**VOLUME****3**GROUP
EngineNUMBER
010MODEL
SedonaDATE
May 2003

Technical Service Bulletin

SUBJECT**Sedona Charging System**

This bulletin provides information related to charging system changes in 2003MY Sedona models to improve alternator output during high ambient temperature severe operating conditions.

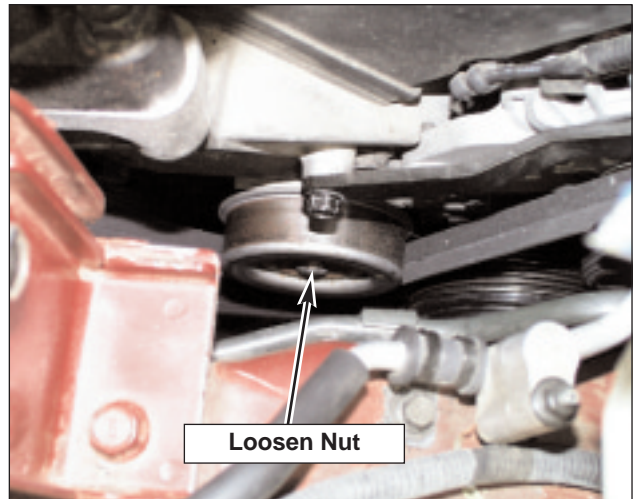
Some 2002 and 2003MY Sedona models built before 2/28/03 production may experience battery discharge when operated in high ambient temperatures for extended periods of time at low speeds or at idle with A/C, headlamps and other accessories on. Typically this results in customers reporting an inability to restart vehicle. To reduce incidence of battery discharge complaints, the following changes were made from 2/28/03 production:

- Battery heat cover added
- New alternator with smaller pulley (65mm -> 55mm)
- ECM battery compensation revised.

BATTERY COVER INSTALLATION:*** NOTICE**

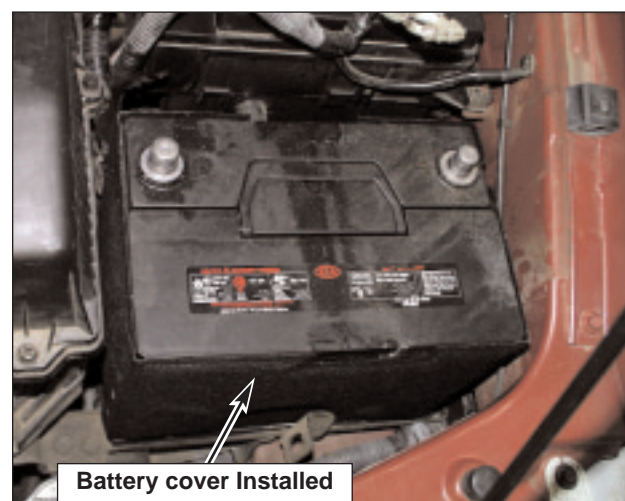
Battery cover will only fit OEM battery.

1. Disconnect both battery cables.
2. Loosen 'J' bolts and remove battery hold-down.
3. Slide battery cover down over battery.
4. Reinstall hold-down and reconnect battery cables.
